# Access Compliance Report

## Public Rights-of-Way

Intersection ID: 3285	Main Street: MALLARD_CREEK_RD	Cross Street: JOHNSTON_OEHLER_RD	Location: N
ADA ID: 5E2AD06806C6	Ramp Type: Para	Initial Pass/Fail: Fail	Overall Compliance: No
Codes/Mitigation Info/Possible Solution		Field Measurements/Component Compliance	
Severity Score: 26.25

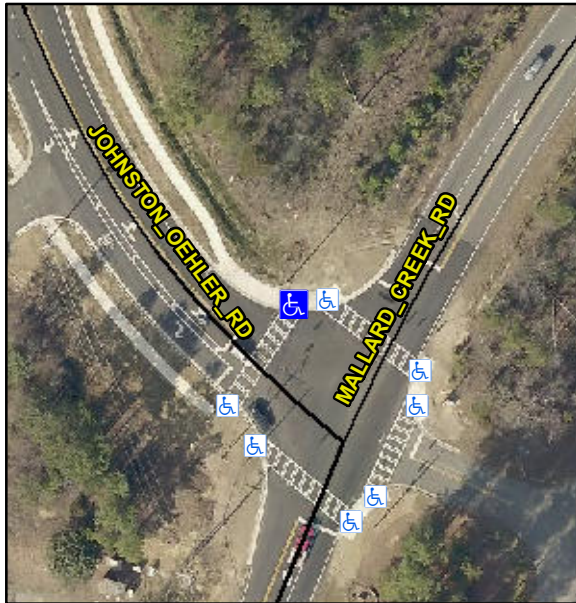
**RT RP < 5%**

**R304.3.2, R304.5.3**

Compliance	Description	Data	Compliance	Description	Data
N/A	Ramp Length LT (in)	60.0	N/A	Ramp Length RT (in)	62.0
Yes	Ramp Width LT (in)	96.0	Yes	Ramp Width RT (in)	96.0
No	Ramp Slope LT (%)	13.8	Yes	Ramp Slope RT (%)	4.0
No	Ramp XSlope LT (%)	3.6	Yes	Ramp XSlope RT (%)	0.7
N/A	Landing Length (in)	N/A	N/A	DWS Provided?	N/A
N/A	Landing Width (in)	N/A	N/A	DWS Contrast?	N/A
N/A	Landing Slope (%)	N/A	N/A	DWS Length (in)	N/A
N/A	Landing X Slope (%)	N/A	N/A	DWS Full Width?	N/A
N/A	Landing Curb? (Y/N)	N/A	N/A	DWS Offset (in)	N/A
N/A	Shared Landing?	N/A			
N/A	Gutter Ponding?	N/A	N/A	Gutter Slope (%)	N/A
N/A	Gutter Lip Ht (in)	N/A	N/A	Gutter X Slope (%)	N/A
N/A	Painted X Walk1?	Yes	N/A	Painted X Walk2?	N/A
	X Walk 1 Direction	To SW		X Walk 2 Direction	N/A
N/A	X Walk 1 Width (in)	104.0	N/A	X Walk 2 Width (in)	N/A
	X Walk 1 Slope (%)	4.1		X Walk 2 Slope (%)	N/A
	X Walk 1 X Slope (%)	0.6		X Walk 2 X Slope (%)	N/A
N/A	Ramp inside XWalk1?	Yes	N/A	Ramp inside XWalk2?	N/A

**Remove & Replace Entire Ramp.**
